Joint Task Force-Red Hill

Bi-Monthly Quality Validation Working Group Meeting

22 June 2023

Quality Validation Report

Existing Pipe Support 45.

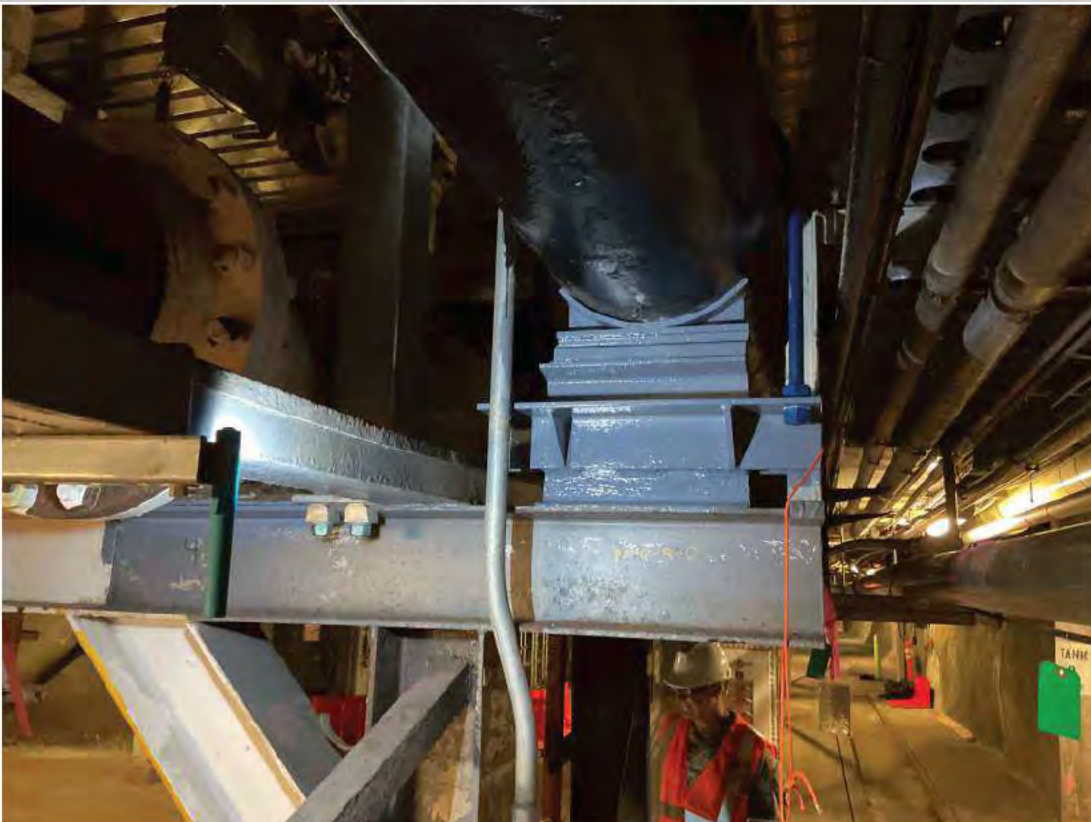
Source	PDF Page No.	Facility Geographic Area	Location Reference
(b) (4)	389	Tank Gallery	(b) (3) (A)
Repair Description	Elevated pipe (b) (3) (A) has limited or no lateral restraint. Provide lateral stops as per (b) (4) retrofit concept drawings.		Source Contract Reference 47QSHA18D000Y W912DY21F0025 Service Order 662
Description of Contractor QC Method(s) Used	Methods outlined in detail in QCP.		Contractor QC Records Reviewed QCP and Daily Reports
Description of QA Validation and Observations	QA methods outlined in QASP. JTF-RH secondary QA and 3rd Party QV completed. JTF-RH QV visually inspected repair & reviewed contractor QC documentation. Final acceptance by government. Date: 05 JUN 2023

Comments
 Refer to SGH Memorandum dated 30 NOV 2022. "Provide U-Bolts, as shown in Figure 2, at the following nine pipe support locations: PS-53, PS-55, PS-60, PS-64, PS-71, PS-74, PS-82, PS-85, PS-88." U-bolt repairs were identified at PS-23, PS-25, PS-26, PS-27, PS-34, PS-36, PS-42, PS-45 and PS-47 in the event that the blind flange was not installed at Tank 7/8; while the understanding is that the blind will be in place, these supports were repaired regardless. U-Bolt repairs were performed at the listed locations with the exception of PS-25 and PS-26. Due to space constraints, U-bolt installation was not feasible. Instead a horizontal member was attached to prevent "escape" of the pipe from the saddle. Reference 08 December email communication with SGH.

New welded bracket and U-bolt restraints at Pipe Support 45.

Existing Pipe Support 74.

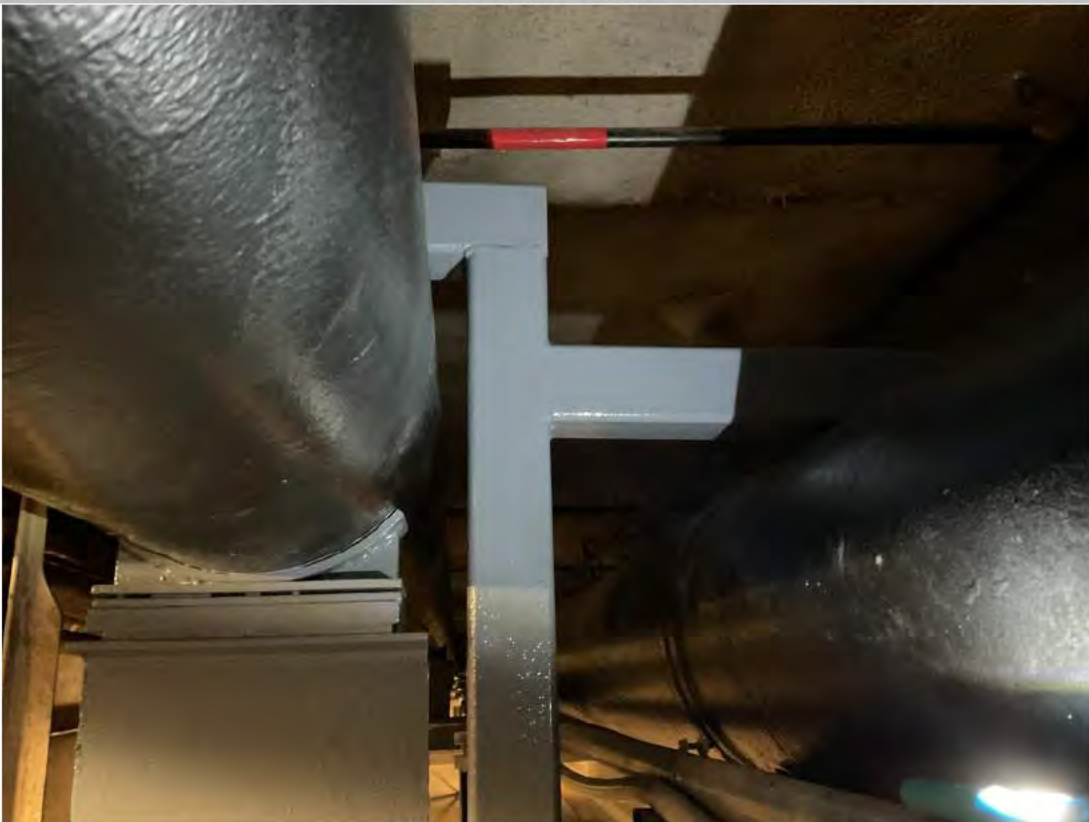
Source	PDF Page No.	Facility Geographic Area	Location Reference
(b) (4)	390	Tank Gallery	(b) (3) (A)
Repair Description	Elevated pipe (b) (3) (A) is not supported, cradle is missing. Provide missing cradle and lateral stops.		Source Contract Reference 47QSHA18D000Y W912DY21F0025 Service Order 662
Description of Contractor QC Method(s) Used	Methods outlined in detail in QCP.		Contractor QC Records Reviewed QCP and Daily Reports
Description of QA Validation and Observations	QA methods outlined in QASP. JTF-RH secondary QA and 3rd Party QV completed. JTF-RH QV visually inspected repair & reviewed contractor QC documentation. Final acceptance by government. Date: 05 JUN 2023		
Rework Needed		Photo Record Attached	Repair Work Validated as Complete
<input type="radio"/>	Yes	<input checked="" type="radio"/>	No
		See Page 2.	<input checked="" type="radio"/> Yes <input type="radio"/> No

Refer to SGH Memorandum dated 30 NOV 2022. "The repairs below supersede those for lateral restraint in our April 2022 report. The updated SGH's recommended repairs for pipe supports of the JP-5 fuel line **(b) (3) (A)** is to provide U-Bolts as shown in Figure 2 for the following six pipe support locations; PS-18, PS-19, PS-20, PS-45, PS-74, PS-85. Note that PS-45, PS-74, and PS-85 are not listed in SGH Item No. LAT-20, but they are shown in Appendix A.3 of the SGH Final Assessment Report." U-Bolt repairs were performed at the listed locations with the exception of PS-74. Due to space constraints, U-bolt installation was not feasible. Instead a horizontal member was attached to prevent "escape" of the pipe from the saddle. Reference 08 December email communication with SGH.

Installed missing cradle and lateral stops at Pipe Support 74.

Representative photo of existing conditions within Pipe Support range.

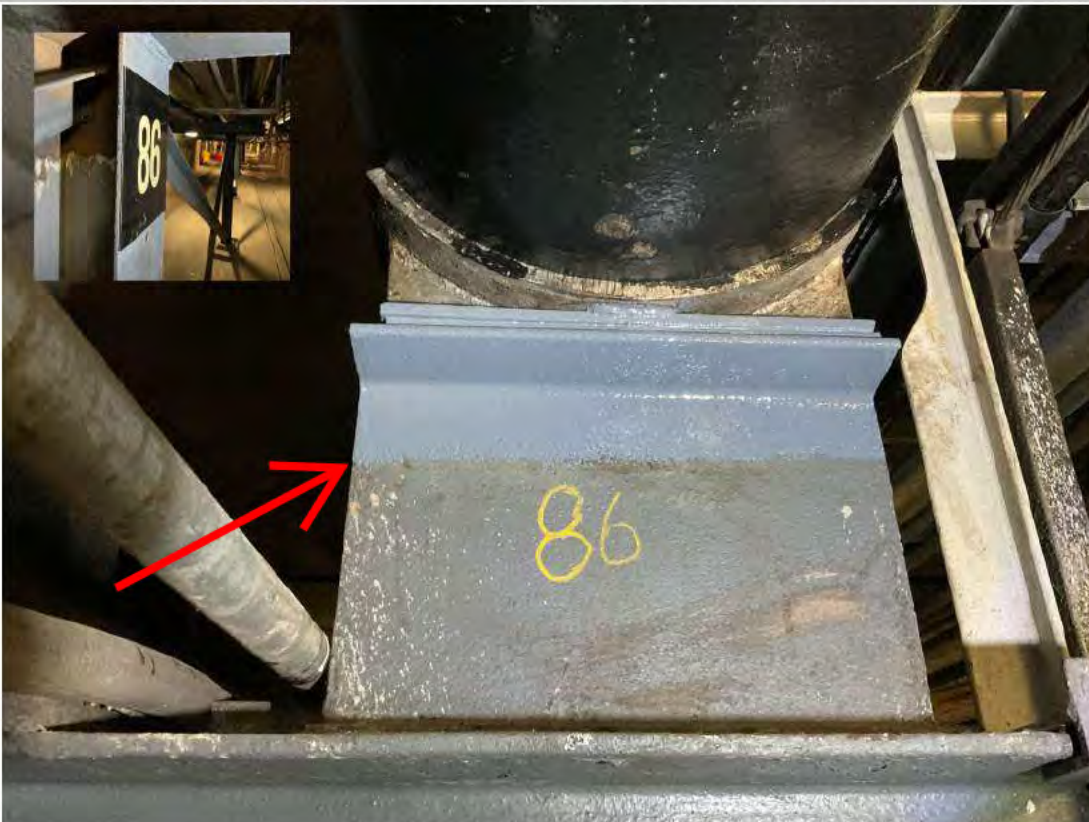
Source	PDF Page No.	Facility Geographic Area	Location Reference
NDAAs	40	Tank Gallery	(b) (3) (A)
Repair Description	F-24 pipeline is unsupported between supports. Support is partial engagement on one side of the pipeline. Shim the pipe or adjust pipe supports to uniformly support the pipe.		Source Contract Reference 47QSHA18D000Y W912DY21F0025 Service Order 662
Description of Contractor QC Method(s) Used	Methods outlined in detail in QCP.		Contractor QC Records Reviewed QCP and Daily Reports
Description of QA Validation and Observations	QA methods outlined in QASP. JTF-RH secondary QA and 3rd Party QV completed. JTF-RH QV visually inspected repair & reviewed contractor QC documentation. Final acceptance by government. Date: 05 JUN 2023		
Rework Needed		Photo Record Attached	Repair Work Validated as Complete
<input type="radio"/>	Yes	<input checked="" type="radio"/>	No
		See Page 2.	<input checked="" type="radio"/> Yes <input type="radio"/> No

Re-seated and shimmed line at PS-86.

Existing condition: valve weeping by through grate into secondary containment trench.

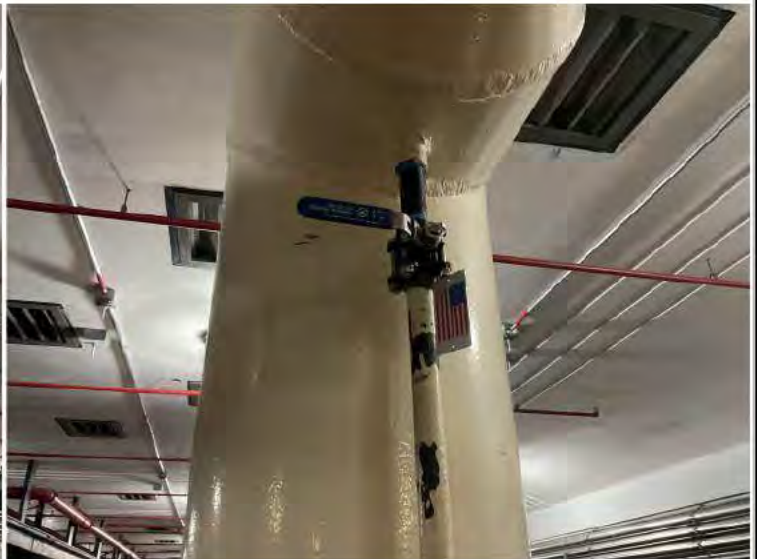
Repair Description Cont.: "Service or replace valve (b) (3) (A)

Replaced (b) (3) (A) valves on both sides of the JP-5 header.
